Inner Sydney high school
Response to Submissions - Architecture
NSW Department of Education

fjmt studio architecture interiors urban landscape community
04 October, 2017 - Document ref - Rev 01

3.0 Response to Submissions

Diagram 5d Views of heritage roof scapes from the internal courtyard

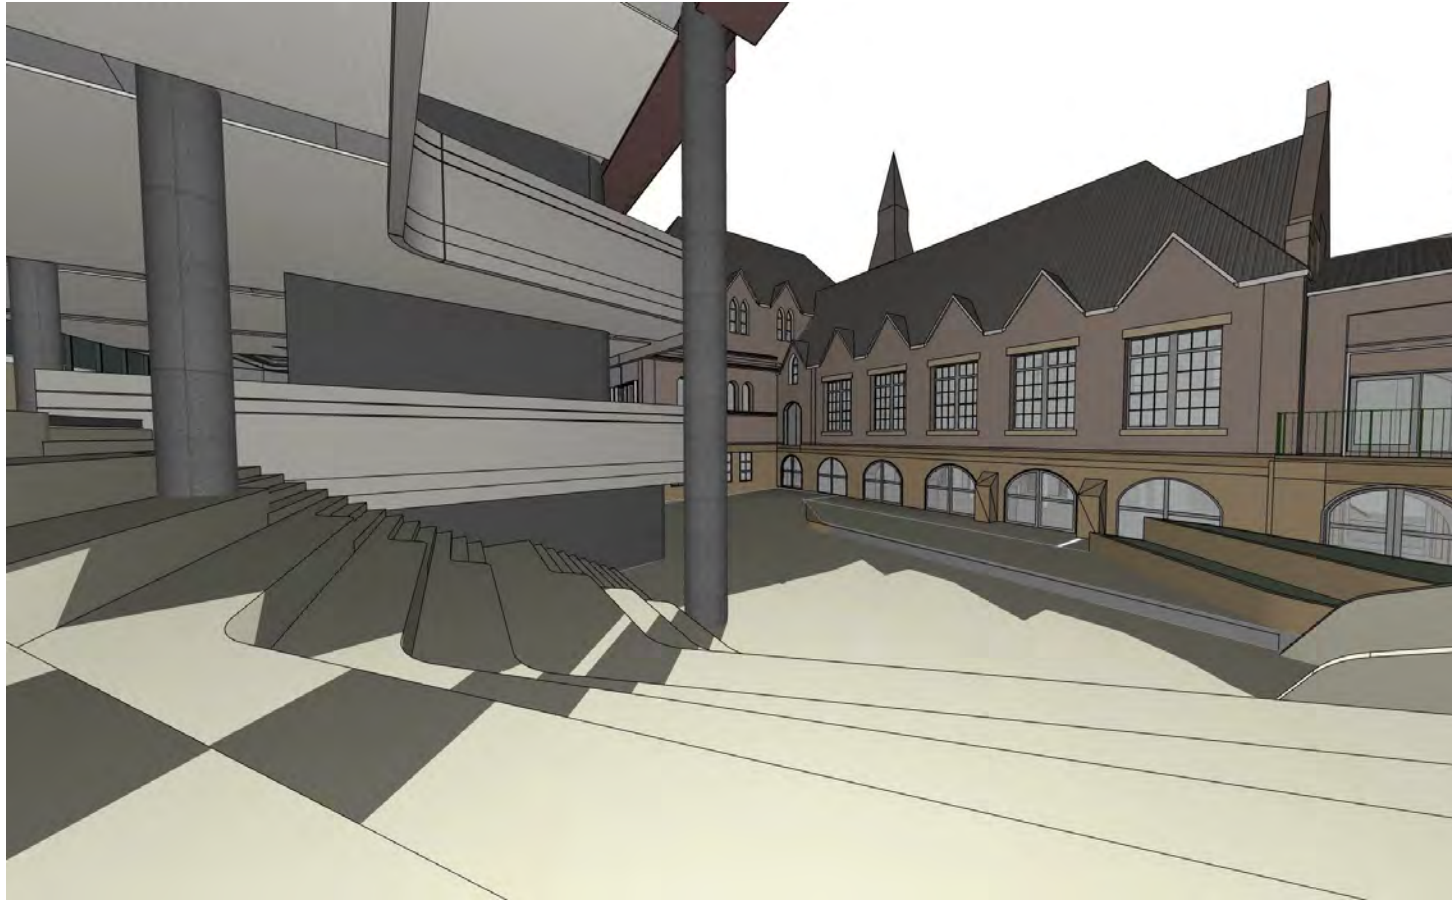
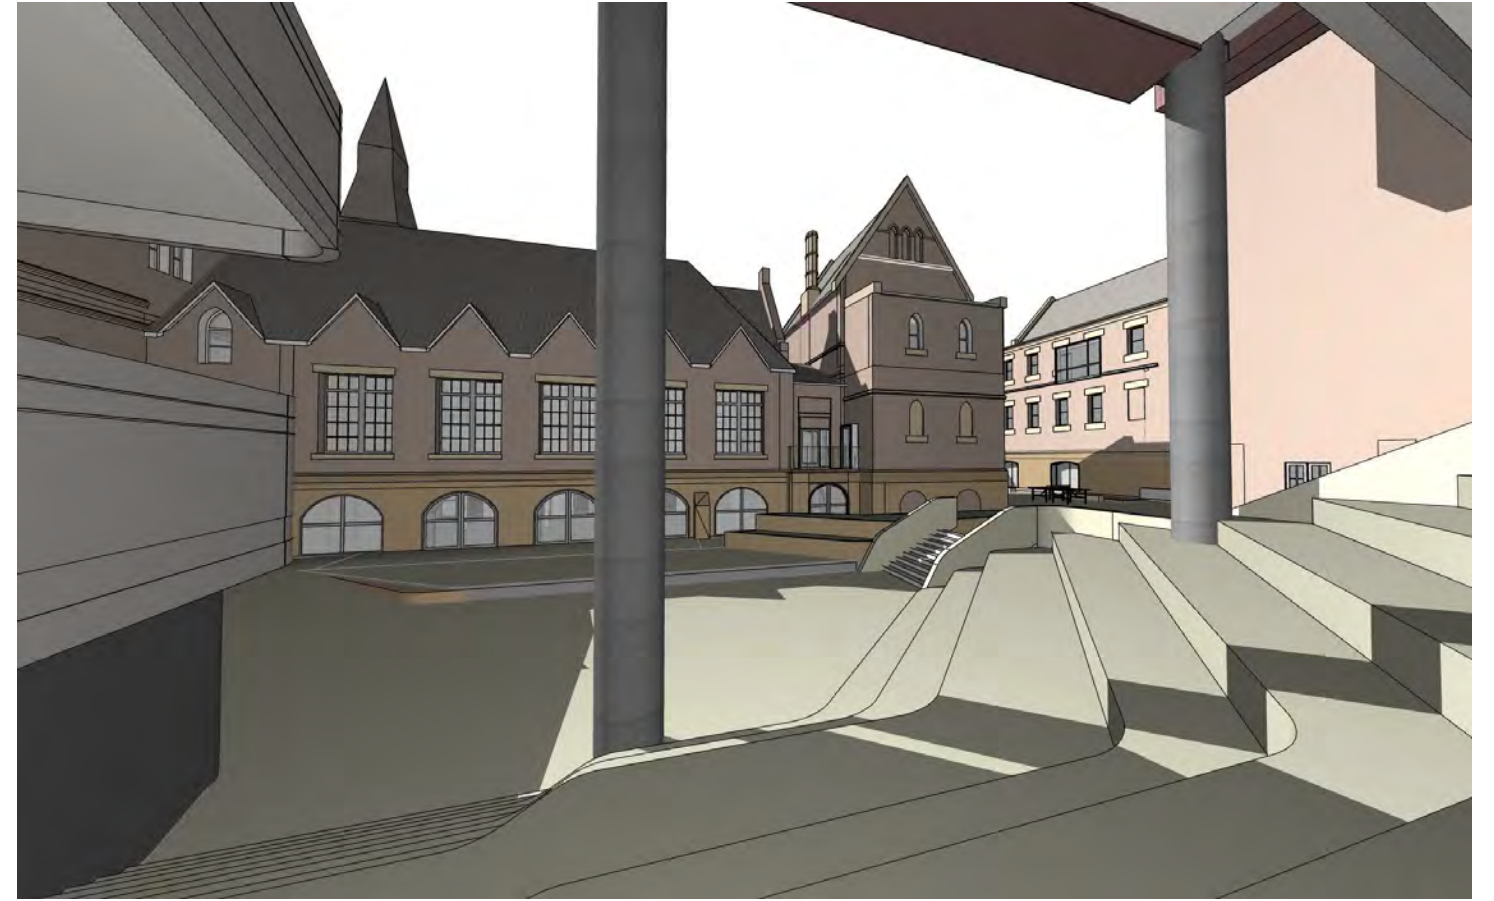
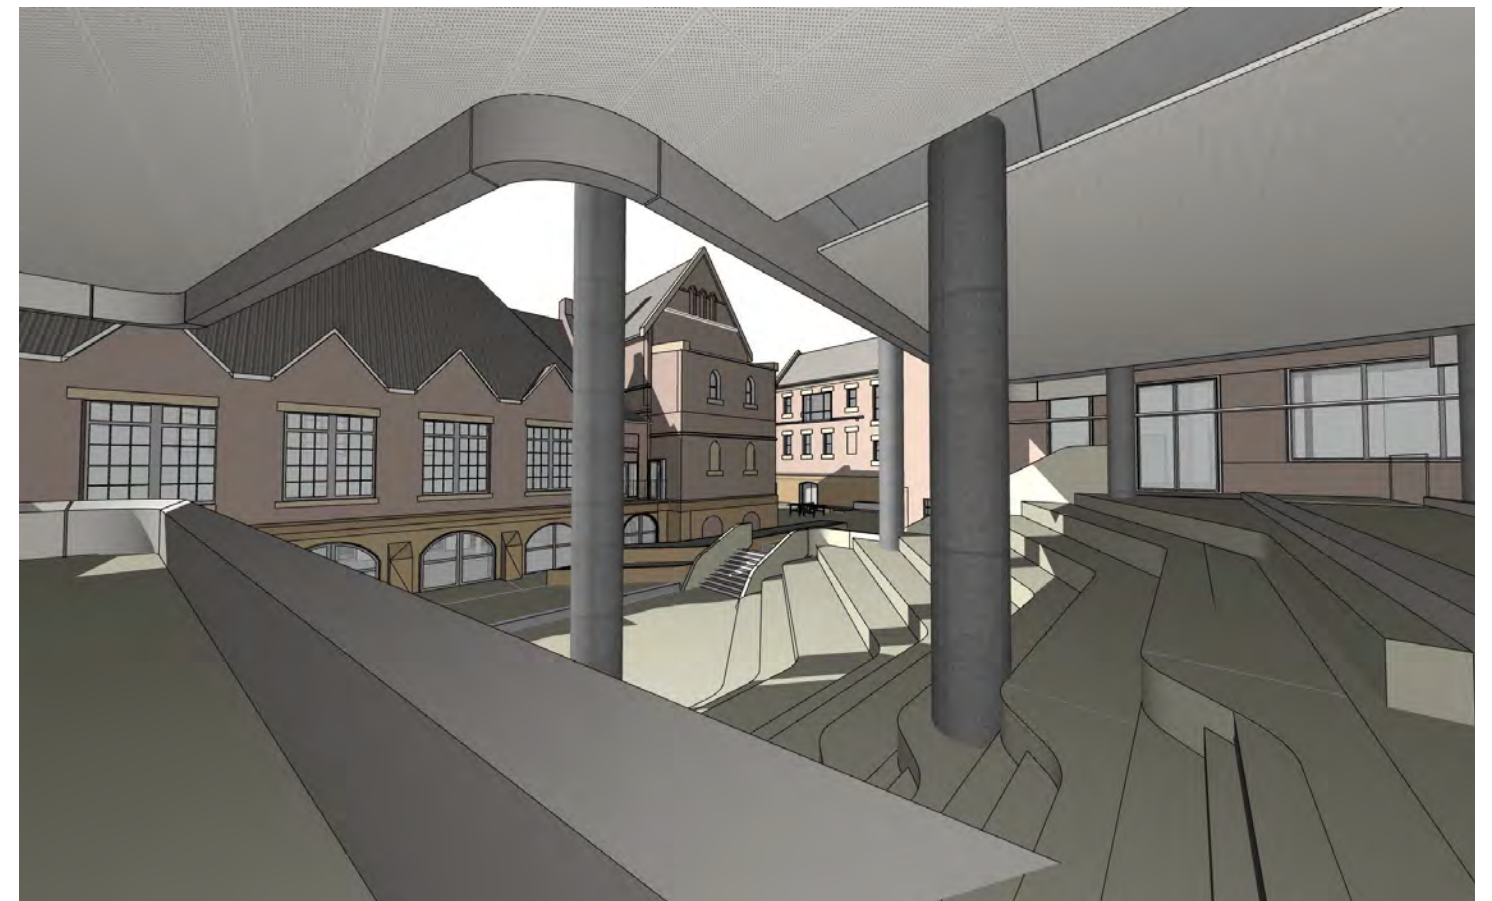
5	Heritage Recommendations	Refer updated HIS from Weir Phillips
	It is considered that some aspects of the design may be improved to minimise the impact on the retained heritage buildings.	
5a	Consideration should be given to reducing the new building's visual impact on the setting of the park by simplifying the building form and material palette of the tower section;	Refer Item 2 response.
5b	Visual analyses should be conducted to understand the visual impact of the new building on the retained heritage buildings. The key vantage points need to be tested including on the opposite Chalmers Street footpath and opposite of the northeast courtyards.	
5c	The new building's impact on the roofscape and the spire of Building 2 is to be further assessed.	Refer Chalmers Street Elevation - East Elevation 3004
5d	In addition, there should be a view analysis of the modified Main Courtyard (in particularly the views from courtyard to Building 2 and 1). The findings of these analyses should be considered to guide for revising or refining the new building design;	Refer Diagram 5d

View from Ground Level terrace at the upper level of the new seating stairs looking north/east.

View from Ground Level terrace at the upper level of the new seating stairs looking south/east.

Diagram 5h Views of new “ribbon” balustrade

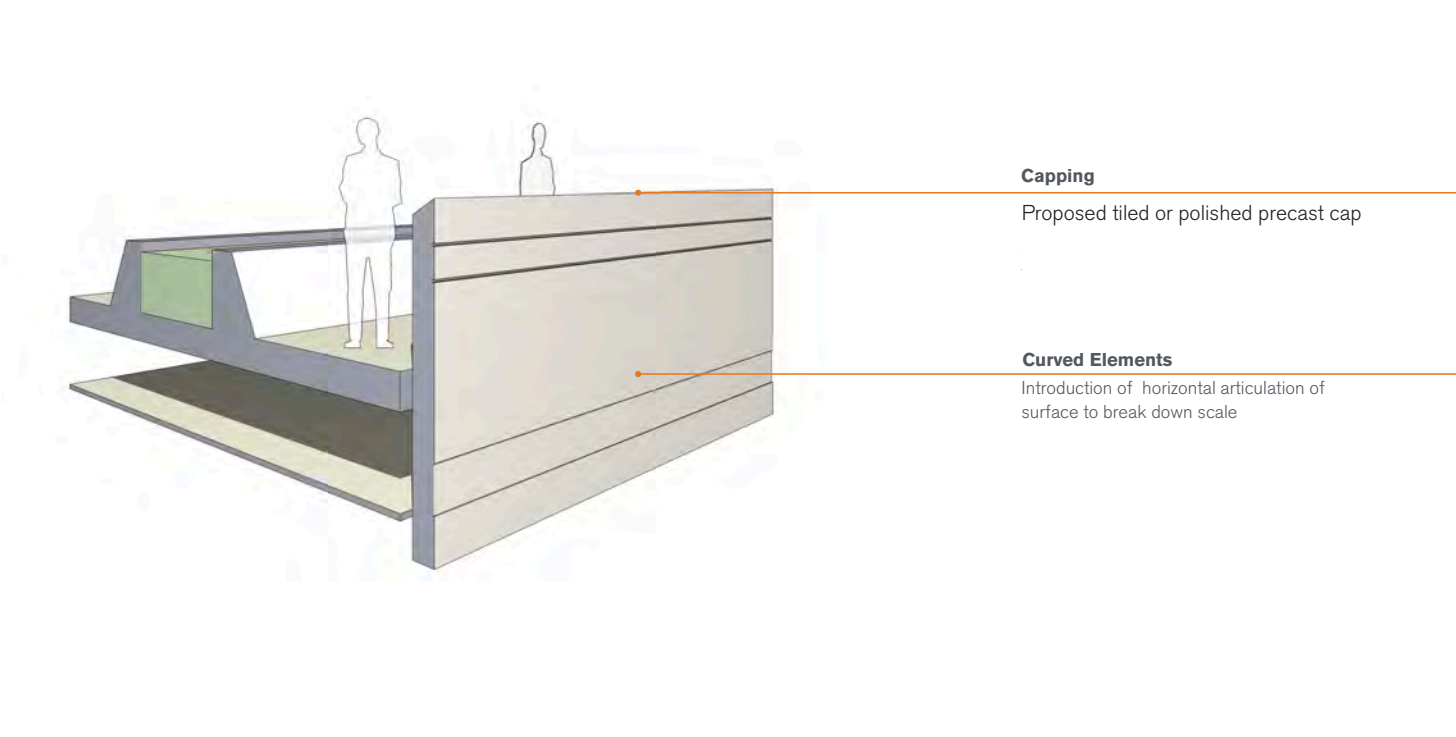
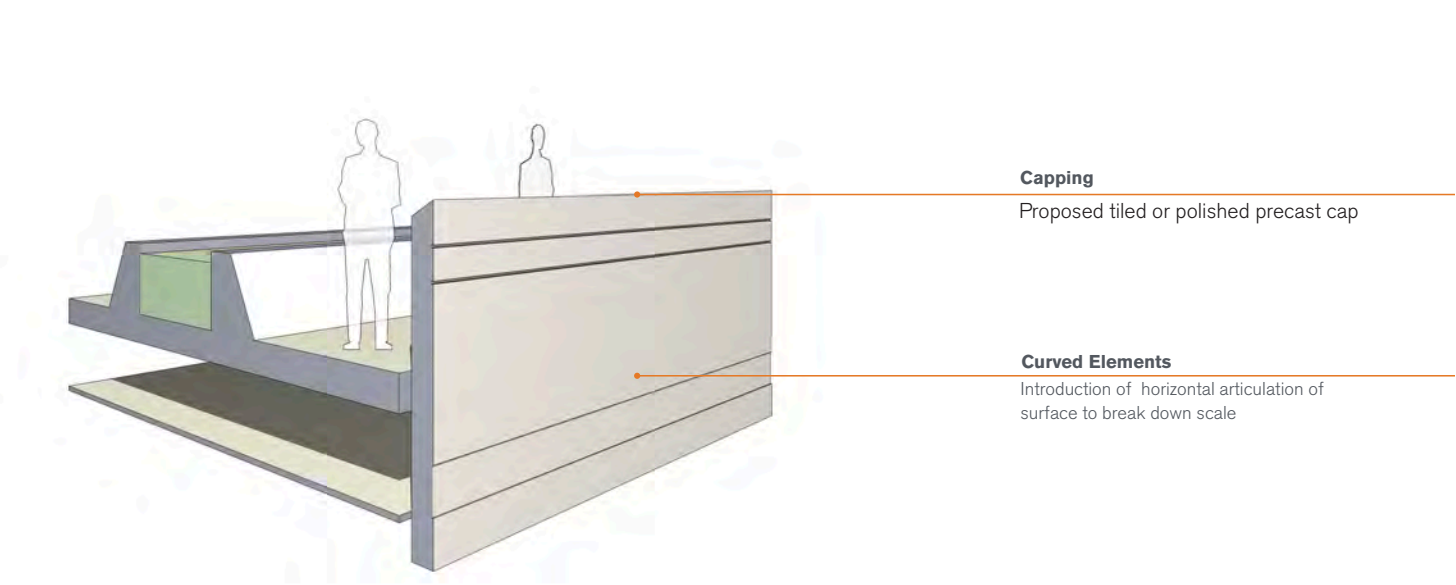
A: 220661_City of Sydney Submission_2017Aug17_1223	
5h	The curvilinear form at Ground and First Floors are considered to mitigate the new building's impact on the heritage buildings. It may be appropriate that this design language is extended to level 2-5, in particular the four corners. The curved corners probably will soften the new building's impact to the roofs of the heritage buildings.	The design response to the landscape terraces has been modified to address concerns of bulk and scale, safety, climb ability and build ability. The revised response is developed as a series of landscaped terraces with "ribbon like" balustrades. The geometry of these balustrades respond to the geometry of the adjacent pool and are subtly curved at each change of direction to provide a contrast of expression to the solid forms of the heritage fabric. These ribbons will weave up through the landscaped terraces in the form of the connecting stair balustrades. Refer Diagram 5h.

View of curved 'ribbon' balustrades from Level 01 looking towards main entrance

Ribbon balustrade detail indicating relocated planter to address maintenace and to provide a better integration of planting into learning areas

View of curved 'ribbon' balustrades from Ground Level looking towards the Library

Diagram 8e Landscaped terraces facade type

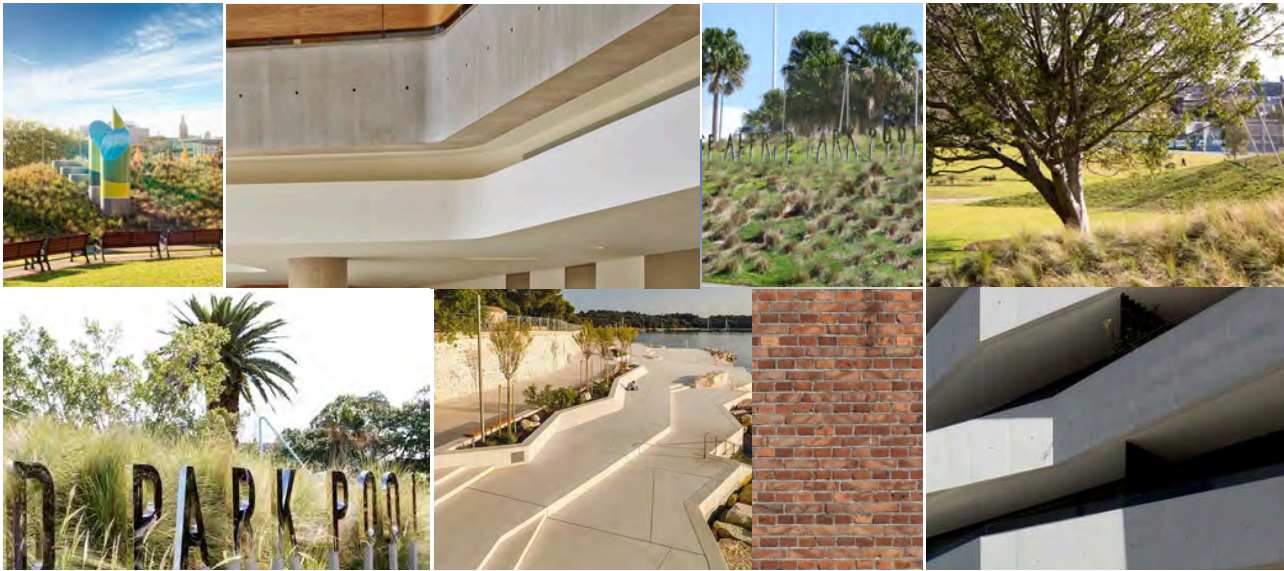
8e	FT04a: A brick selection is required. No detail is provided on the finish or colour of the aluminium glazing framing or the aluminium blades.	The Studio facade has been further developed to provide a quieter response to act as a backdrop to the heritage facades. A neutral, darker colour is proposed to the masonry which will be a panellised terracotta, porcelain or ceramic material. Following a review by the Design Integrity Panel, it is proposed that prototype panels will be reviewed in situ prior to the final colour selection. The aluminium framing will be a dark bronze colour. Refer updated elevations for further detail. Refer Elevations
8e	FT05: No detail is provided on the finish or colour to the spandrel strips, off-form concrete, and aluminium framing. Further detail should be provided to confirm that the aluminium extrusion proposed is capable of being curved to the extent shown in the proposal within the limitations of the project budget. If this is not capable of being achieved, a suitable alternative should be provided prior to completion of the assessment to avoid an inferior substitution at later stages. A segmented blade would not achieve the 'organic' design intent for the lower levels of the buildings.	The design response to the landscape terraces has been modified to address concerns of bulk and scale, safety, climb ability and build ability. The revised response is developed as a series of landscaped terraces with "ribbon like" balustrades. The geometry of these balustrades respond to the geometry of the adjacent pool and are subtly curved at each change of direction to provide a contrast of expression to the solid forms of the heritage fabric. The proposed material will be either a light grey pigmented off form concrete or precast with either a terracotta/tiled cap or a polished precast cab dependant upon the final selection of material. Refer Diagram 8e

Prince Alfred Park materials and finishes
Introduction of a neutral masonary ribbon to the landscaped terraces

Diagram 12e Basement and Tower Egress Strategy Diagram

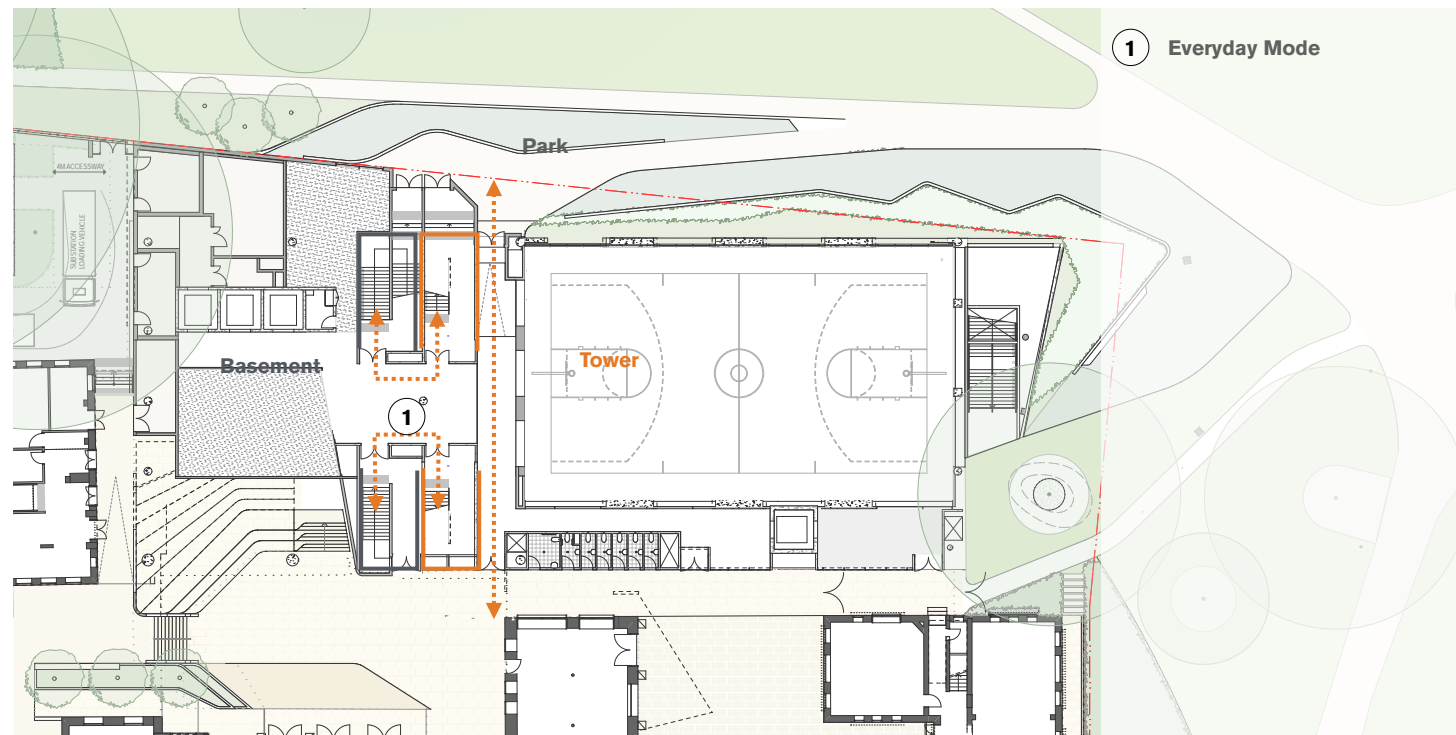
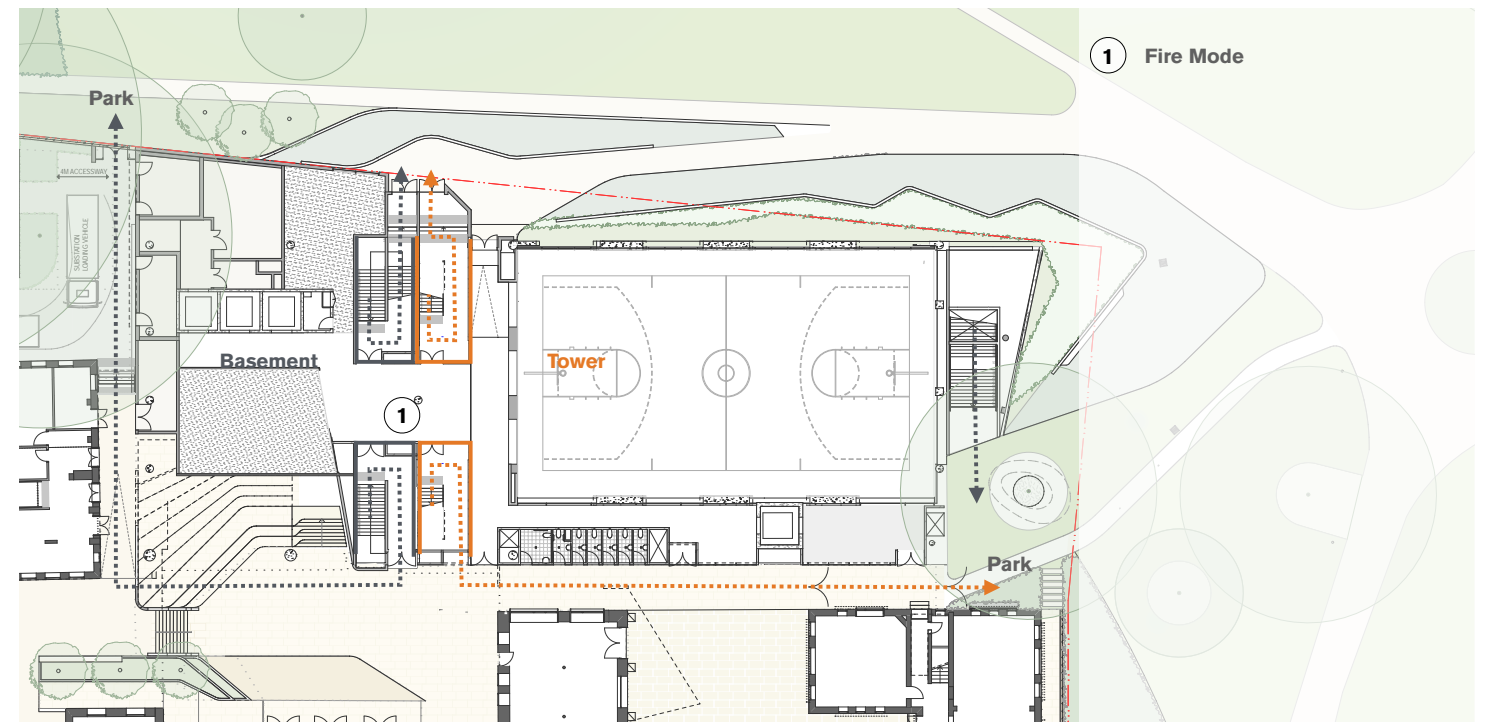
A: 220661_City of Sydney Submission_2017Aug17_1223	
12e	It should be requested that a diagram be provided which shows how the school population is evacuated in an emergency, showing BCA compliance for egress widths and exit travel distances, and any engineered solution being relied upon to achieve compliance.	Refer Diagram 12e
13	Weather Protection	
13a	<p>The school's café and eating area is at Level 1. The space is almost fully covered by the level above, though is not enclosed at the sides. The elevations appear to show a partial glazed screen at the perimeter, though detail is not provided to describe the height, extent or to confirm adequacy.</p> <p>- Therefore, additional information should be provided to confirm the amenity of the level 1 terrace in adverse weather. There does not appear to be an alternative internal area which provides adequate space for any proportion of students at lunch time.</p>	The brief requirement for Covered Outdoor Area which can be used for Canteen seating in the ESFG is 200m2. The Level 1 terrace is substantially over the requirement. In times of inclement weather, alternative areas of the campus will also be available for recreation. These will include the Movement Studio, the Level 4 terrace and the open area in front of the Library on Ground Level which is directly connected to Level 1. This Ground Level area has been substantially opened up in order to provide additional area for recreation and movement when required.

2 x 2000mm (4000mm) + 1 x 3500mm (1 x 3500mm)
egress from basemen
= 860pax

ie: 200pax for first 2m of egress and then 60pax for every 500mm thereafter

2 x 1640mm (3000mm) egress from tower stairs
